Approved Water Supply Impact Assessment

Proposed Residential Development and Visitor Centre at Various Lots in DD191, Ma On Shan

Submission of Approved Water Supply Impact Assessment Report for Record

Water Supply Impact Assessment

EXISTING AND PROPOSED FRESHWATER SUPPLY LAYOUT PLAN

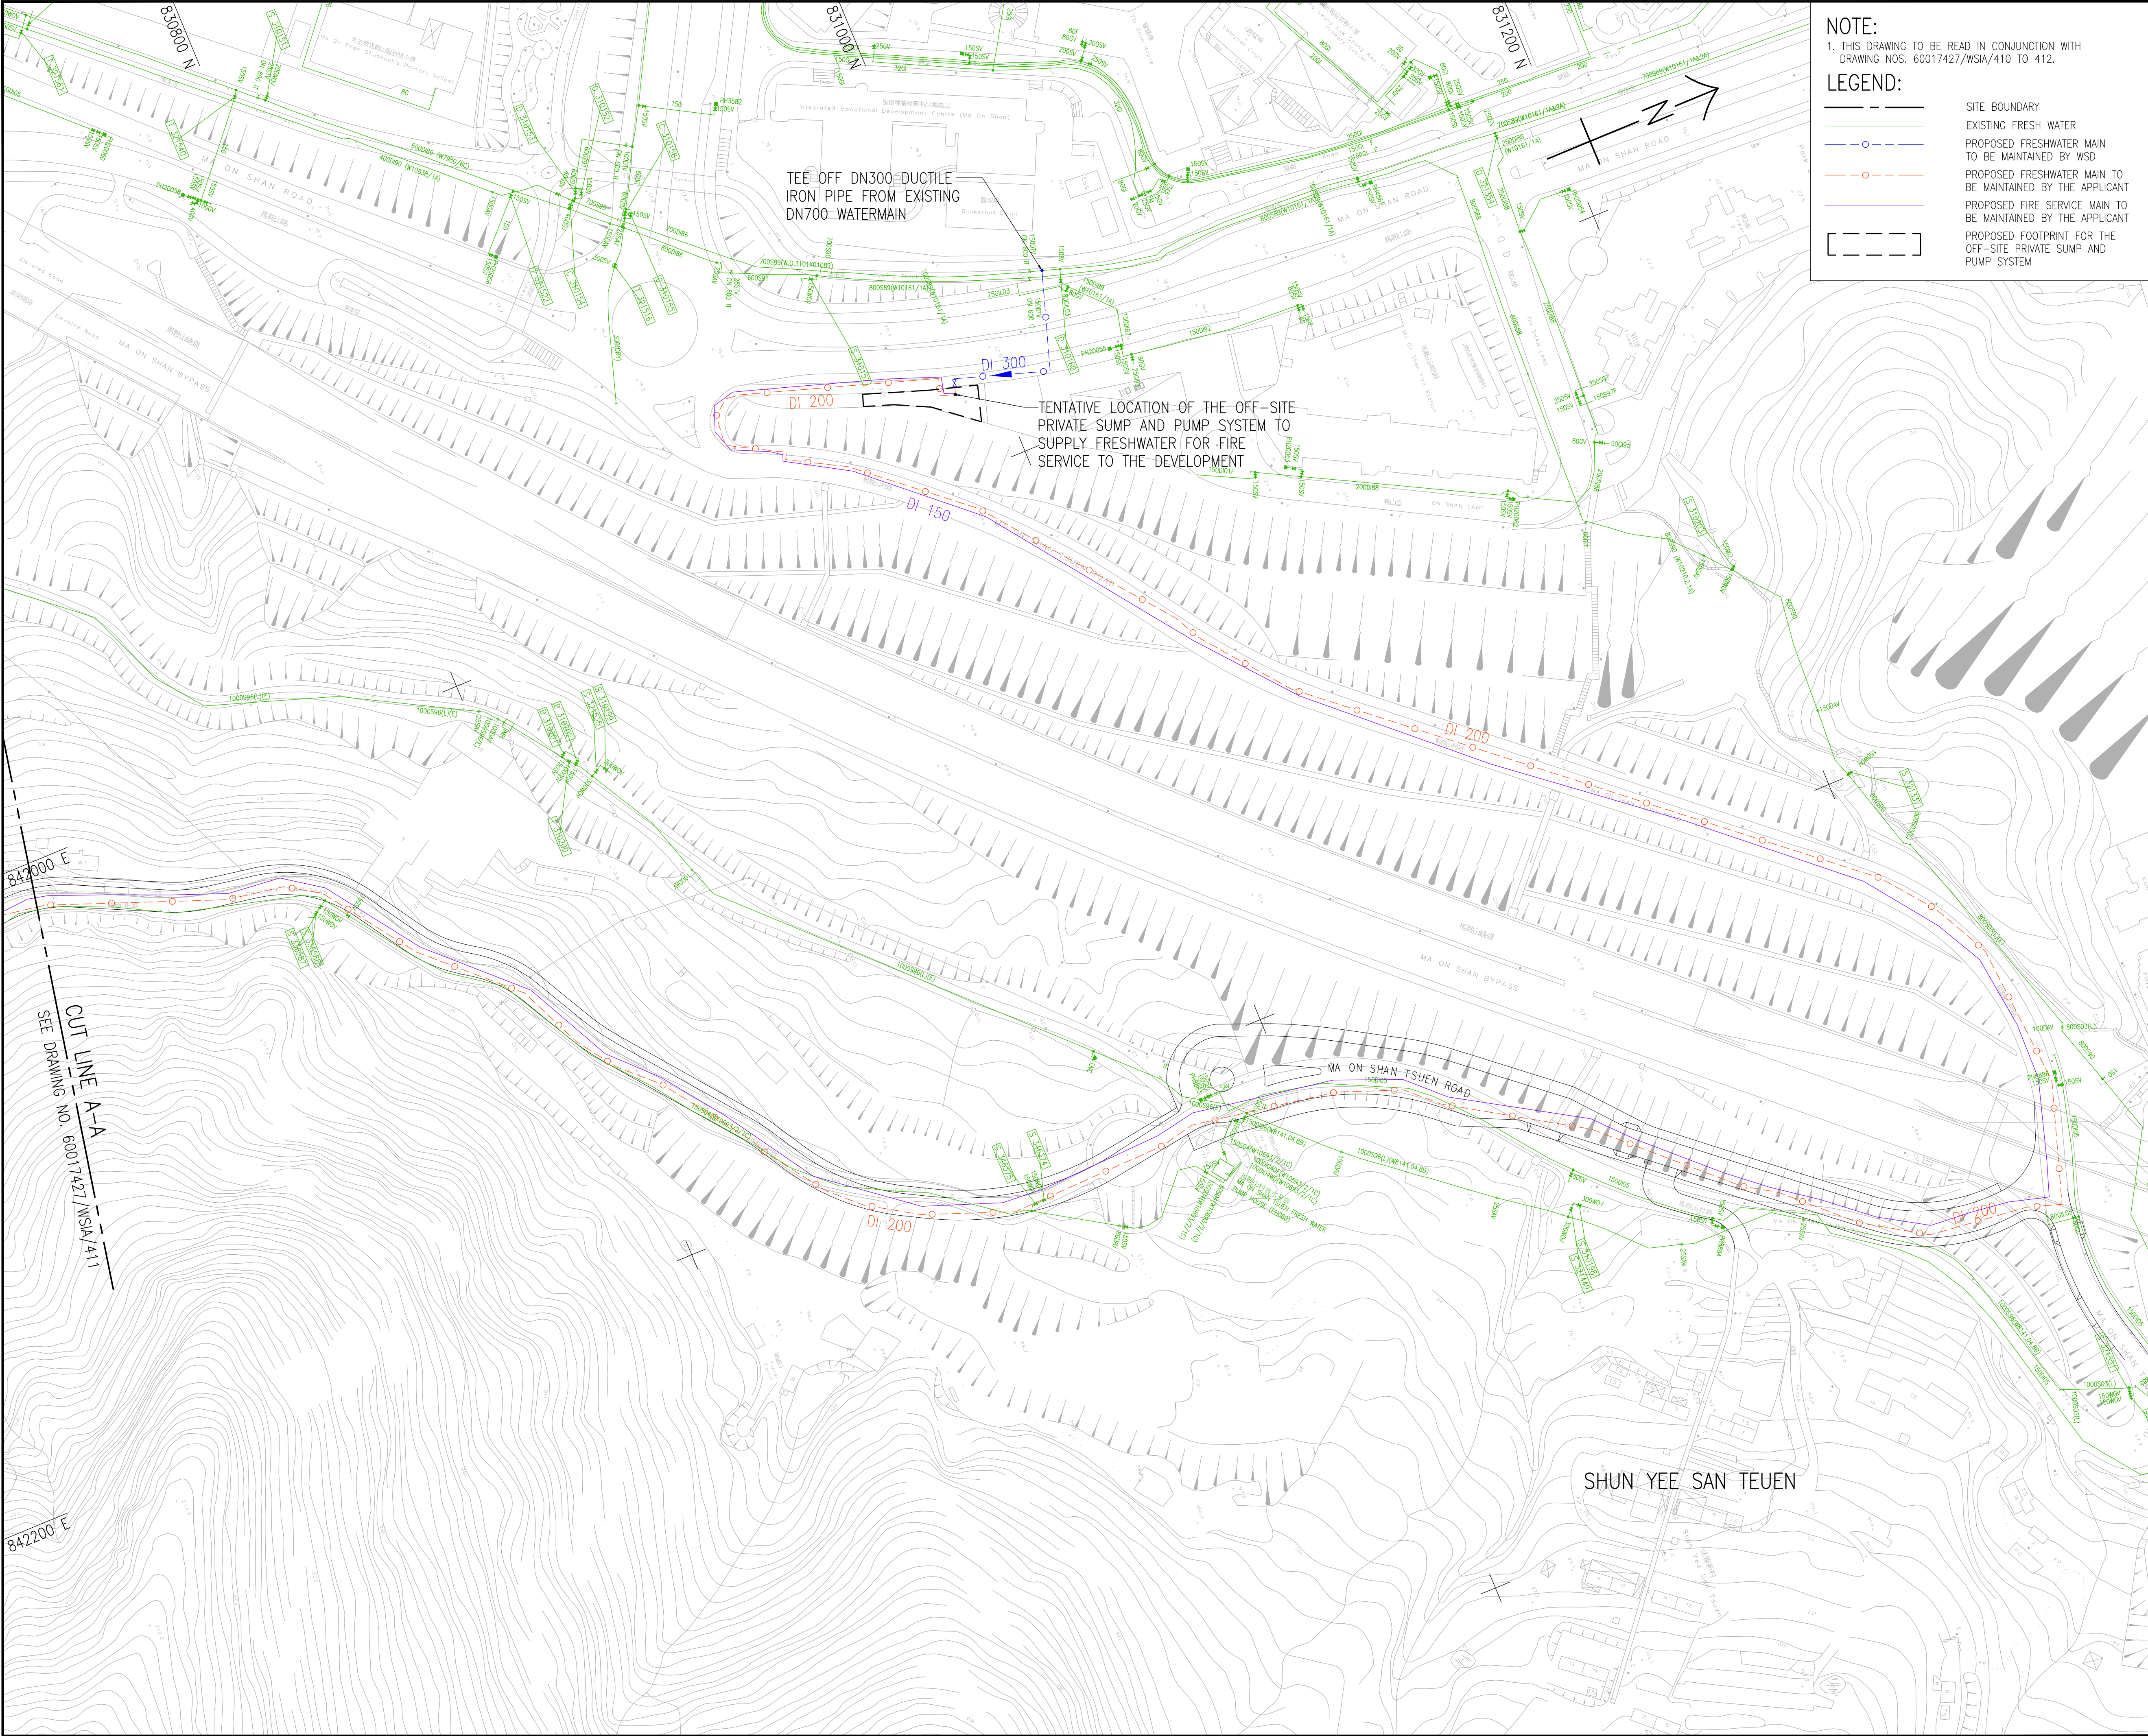
3. According to Technical Requirements for Plumbing Works in Building (TRPW) Cl. 5.1 and 5.4, Fire Service supply must be from an independent connection and the use of water should not be served for purpose other than firefighting. Please advice the proposed arrangement of fire service supply system and show in the revised drawing.

(a) Drawing no. 60017427/WSIA/410 -- it seems that the private fire fighting system is missing. Please review.

(b) Drawing no. 60017427/WSIA/410 to - 415 -- As the private off-site sump and pump system including the private pump house and the associated water mains from the private pump house to the Site are regarded as the "inside services" / "fire service" under the Waterworks Regulations, the applicant should submit the application to the Water Authority for approval.

- 3.3.4 200mm diameter fresh water pipe supplying fresh water and flushing water will be connected from the pump house to the development. A separate 150mm diameter pipe will be connected from the pump house to the development for fire service supply for the proposed development.
